Access Compliance Report

Public Rights-of-Way

(Curb Ramps)

Intersection ID: 10027081	Main Street: GALLERIA_BV	Cross Street: N/A	Location: SW
ADA ID: 5F11F9362678	Ramp Type: PerpDiag	Initial Pass/Fail: Fail	Overall Compliance: No
Codes/Mitigation Info/Possible Solution		Field Measurements/Component Compliance	
Severity Score: 35

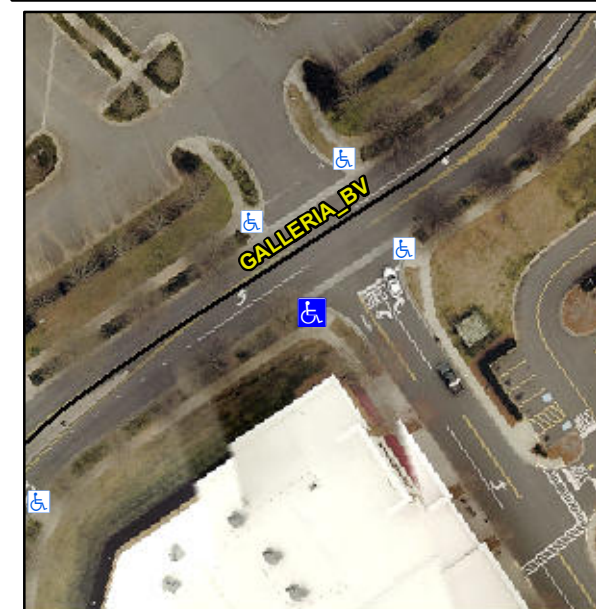
Not Found, R304.5.1

Compliance	Description	Data	Compliance	Description	Data
N/A	Ramp Length (in)	98.0	Yes	Ramp Slope (%)	6.3
No	Ramp Width (in)	28.5	Yes	Ramp XSlope (%)	1.6
N/A	Flare Type LT	N/A	N/A	Flare Type RT	N/A
N/A	Flare Slope LT (%)	N/A	N/A	Flare Slope RT (%)	N/A
N/A	Flare Traversable LT?	N/A	N/A	Flare Traversable RT?	N/A
N/A	Landing Length (in)	N/A	N/A	DWS Provided?	N/A
N/A	Landing Width (in)	N/A	N/A	DWS Contrast?	N/A
N/A	Landing Slope (%)	N/A	N/A	DWS Length (in)	N/A
N/A	Landing X Slope (%)	N/A	N/A	DWS Full Width?	N/A
N/A	Landing Curb? (Y/N)	N/A	N/A	DWS Offset (in)	N/A
N/A	Shared Landing?	N/A			
N/A	Gutter Ponding?	N/A	N/A	Gutter Slope (%)	N/A
N/A	Gutter Lip Ht (in)	N/A	N/A	Gutter X Slope (%)	N/A
N/A	Painted X Walk1?	No	N/A	Painted X Walk2?	No
	X Walk 1 Direction	To NE		X Walk 2 Direction	To N
N/A	X Walk 1 Width (in)	N/A	N/A	X Walk 2 Width (in)	N/A
	X Walk 1 Slope (%)	1.5		X Walk 2 Slope (%)	1.8
	X Walk 1 X Slope (%)	1.0		X Walk 2 X Slope (%)	0.1

Remove & Replace Curb Ramp With Two New Directional Ramps or Equivalent.
